**Re: Contract No. HY/2010/08
Central – Wan Chai Bypass – Tunnel (Slip Road 8 Section)
Additional Mitigation Plan for Slip Road 8 (Rev. 7)**

Additional Mitigation Plan for Slip Road 8 (Revision 7) under FEP-10/364/2009/B for Contract No. HY/2010/08

**Central – Wan Chai Bypass Tunnel
(Slip Road Section 8)
Contract No. HY/2010/08**

Additional Mitigation Plan for Slip Road 8 under condition 2.16 of FEP- 10/364/2009/B

TITLE:
 SETTING OUT PLAN FOR ELDERLY FITNESS AREA AND ADJACENT FOOTPATHS IN VICTORIA PARK

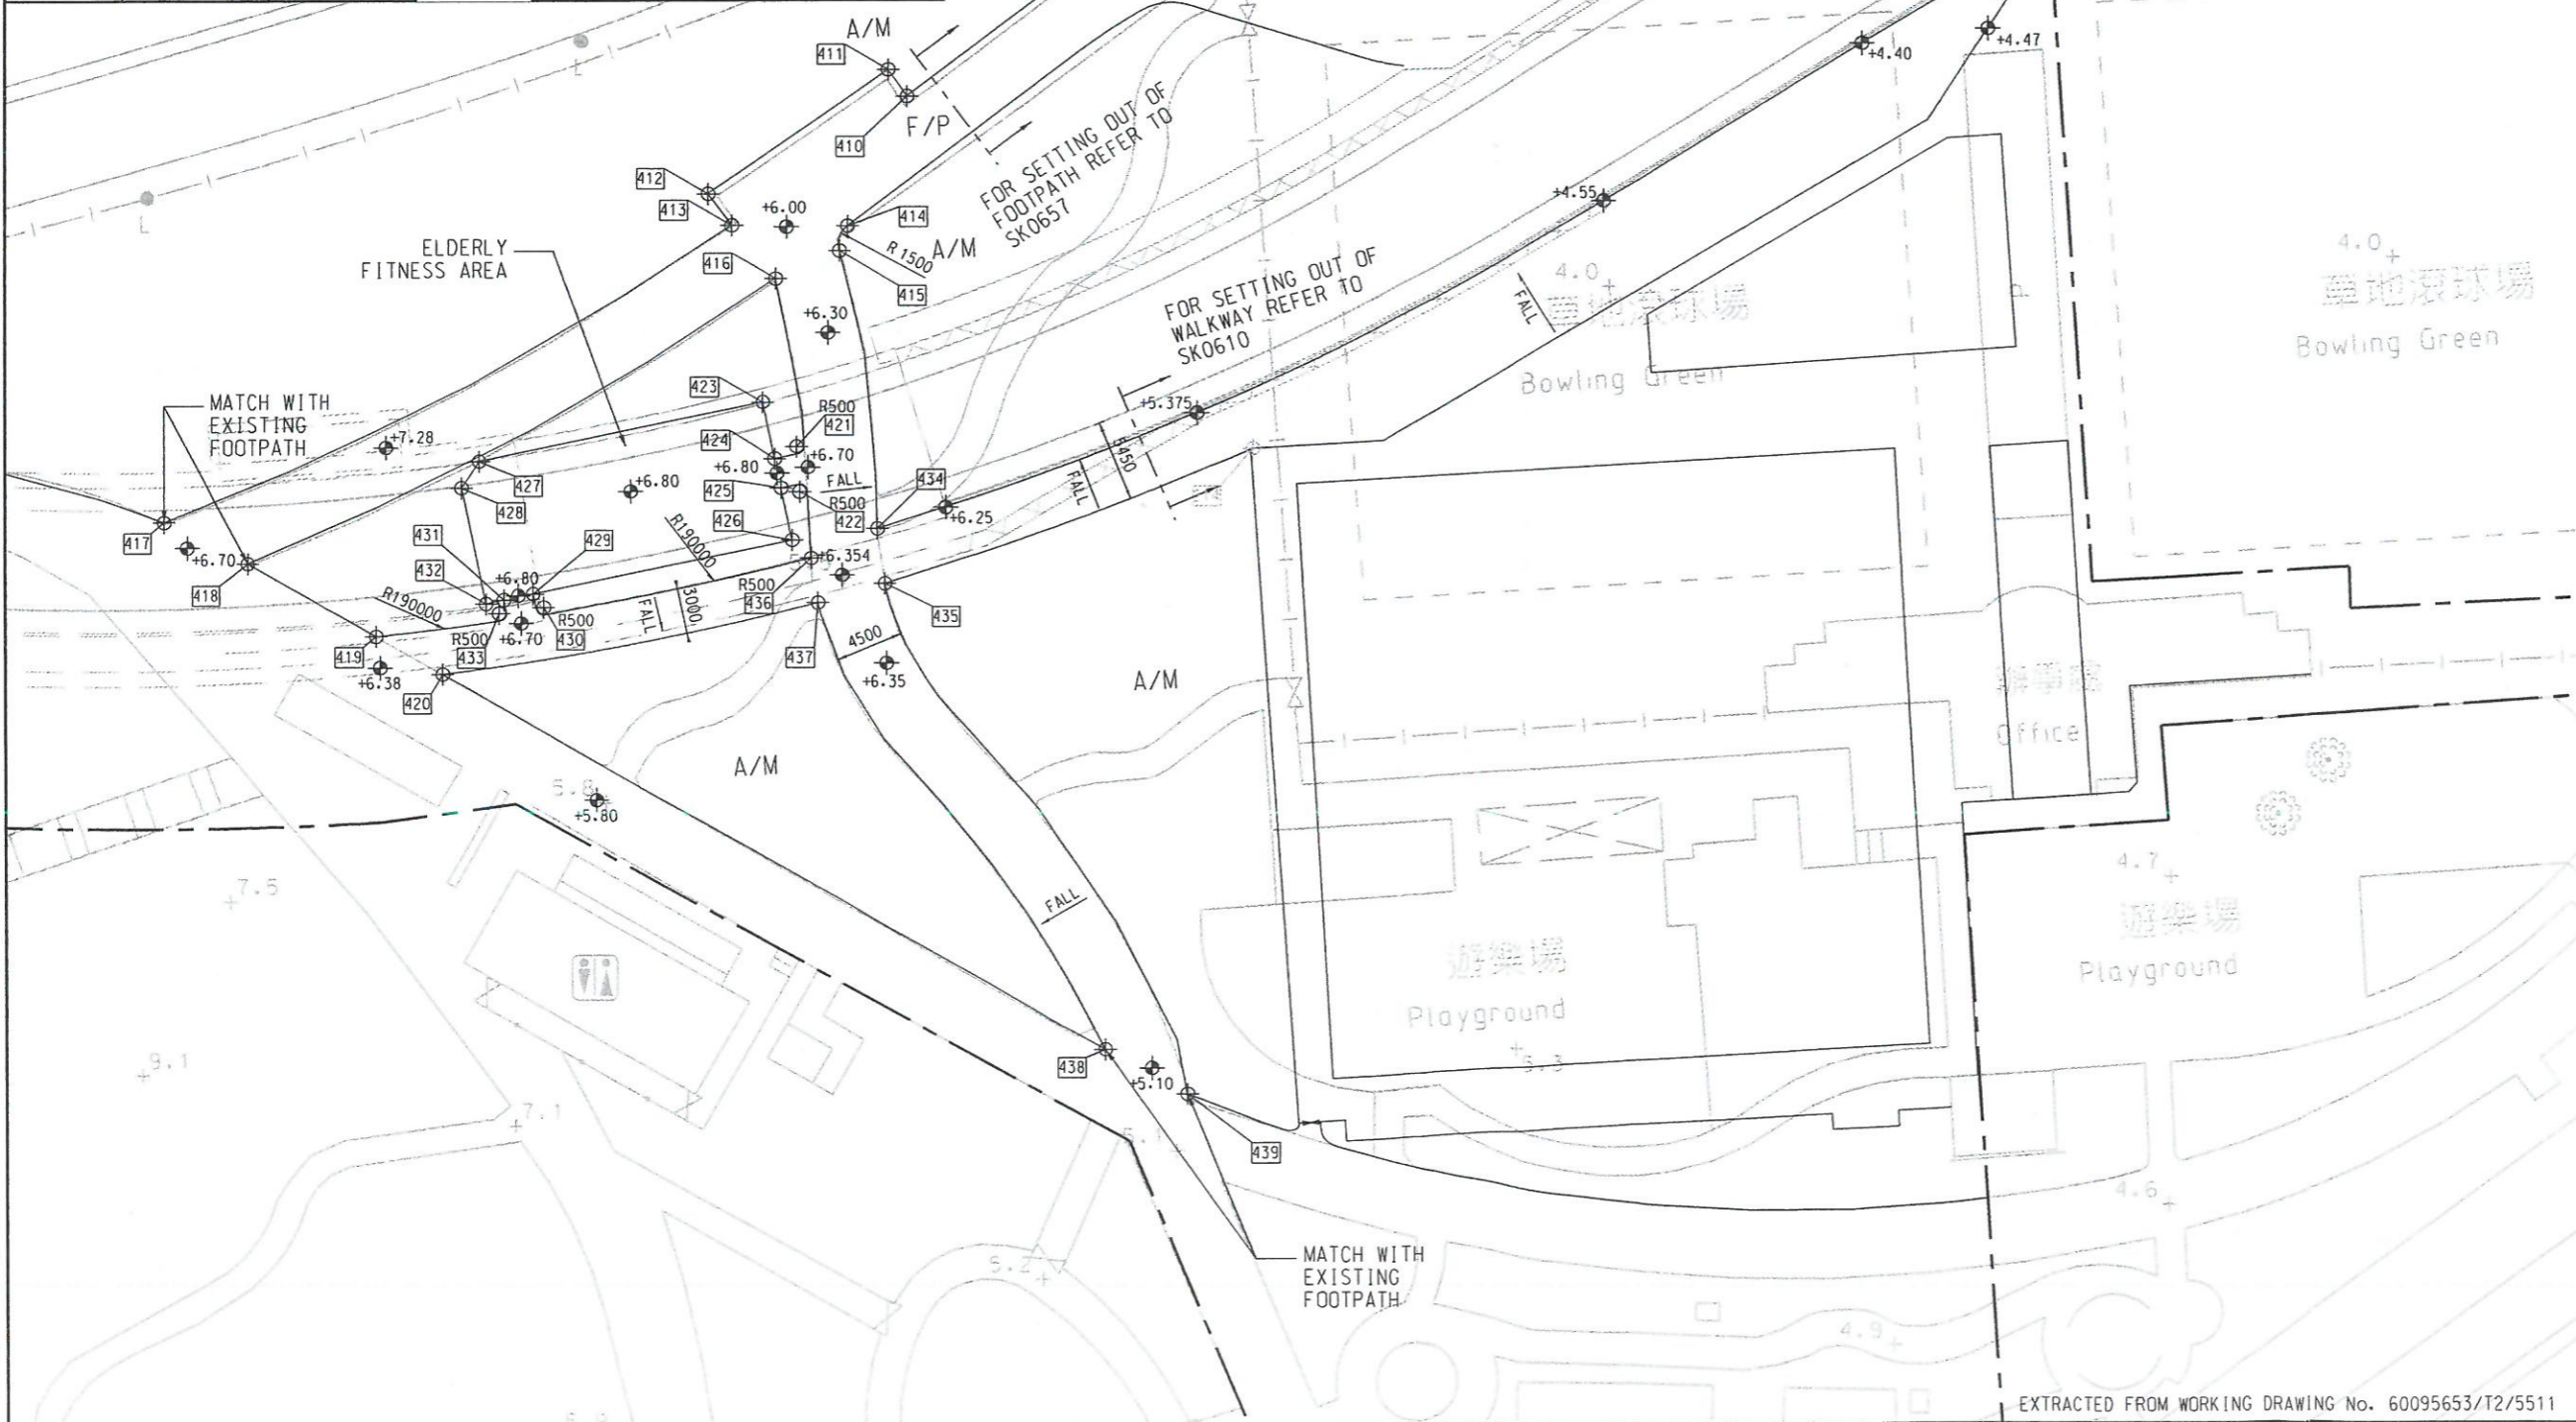
I enclose for your construction a copy of Sketch No. 60095653/T2/SK0690 showing the setting out details for the elderly fitness area and the adjacent footpaths within Victoria Park.
